**VIRGINIA ELECTRIC AND POWER COMPANY**  
**RICHMOND, VIRGINIA 23261**

**VIRGINIA ELECTRIC AND POWER COMPANY**  
**NORTH ANNA POWER STATION UNITS 1 AND 2**  
**PROPOSED TECHNICAL SPECIFICATIONS CHANGES**  
**ELIMINATION OF SEISMIC EFFECTS FROM CONTROL ROD DROP TIMES**  
**REQUEST FOR ADDITIONAL INFORMATION**

Response to Request for Additional Information  
Elimination of Seismic Effects from Control Rod Drop Times

NORTH ANNA UNIT 1 - CYCLE 13 STARTUP PHYSICS TESTS  
 ROD DROP TIME - HOT FULL FLOW CONDITIONS

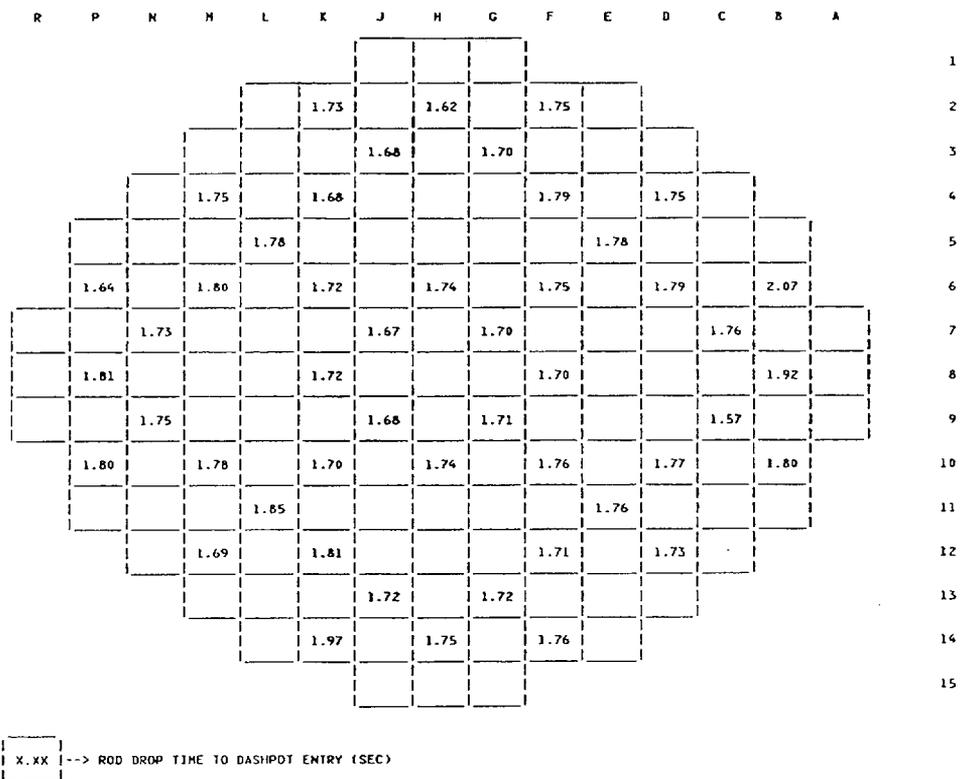
The submittal dated June 22, 2000 indicated that if accident analyses are re-performed, the rod drop time of 2.7 seconds would need to be increased. Such a change would involve concurrent reactor protection system changes (e.g., reductions in high pressurizer pressure and/or low RCS flow reactor trip setpoints). The submittal indicated this would have the potential to reduce normal operating margin and increase the potential for reactor trip events and associated plant equipment transients. Please discuss the potential magnitude of the decreases in the setpoints.

Our evaluation of the effects of using a full core of advanced fuel products (with their associated higher pressure drop and reduced thimble tube ID) concludes that measured rod drop times could potentially increase by as much as 0.5 seconds at North Anna. This increase results from the fact that advanced fuel assemblies have a higher hydraulic resistance and core pressure drop than current generation fuel. This higher pressure drop forces more flow up the RCCA guide tubes, creating more resistance to control rod insertion and, therefore, slightly delayed drop times. The seismic effect amplifies the magnitude of the estimated drop time increase.

Current measured drop times provide slightly in excess of 0.5 second of margin to the 2.7 seconds Technical Specification limit (see attached Figure). However, much of this margin is currently allocated for the seismic allowance.

If the seismic penalty is not eliminated, Dominion estimates that the safety analysis rod drop time will have to be increased from 2.7 seconds to 3.2 seconds to ensure adequate margins for BOC startup tests.
